DIMENSIONS ARE IN MILLIMETERS		PART NO	DATE	33-550-BU	
					UNLESS OTHERWISE SPECIFIED TOLERANCES		APPROVED	DATE	TITLE	
4	INSULATOR	BAKELITE	RED	1	0.5-5	=±0.2	WOUDY		UHF MALE TWIST ON RG213/U	
3	CENTER CONTACT	BRASS	NICKEL	1	5-30	=±0.4	CHECKED	DATE	DRAWING NO	
2	BODY	ZINC	NICKEL	1	30-120	=±0.6	LUCY		FILE NO	
1	SHELL	ZINC	NICKEL	1	120-315	=±1	DRAWN	DATE		
					315-1000	=±1.6	LEO			
					1000-2000	=±2.4				
NO	DESCRIPTION	MATERIAL	FINISH	QTY	SCALE	ISSUE

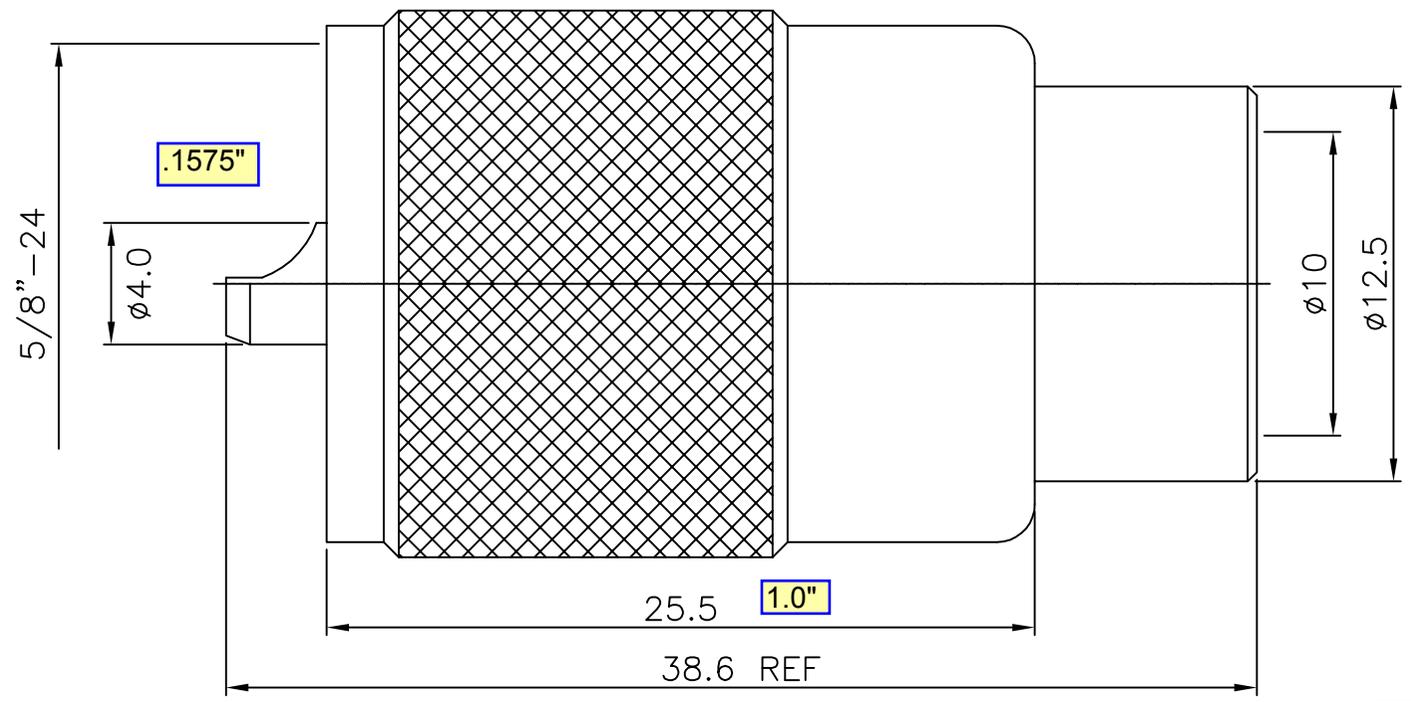
Teflon Insulator ?

solder center pin ?

only 213, what about RG-8, RG-11, & RG-214
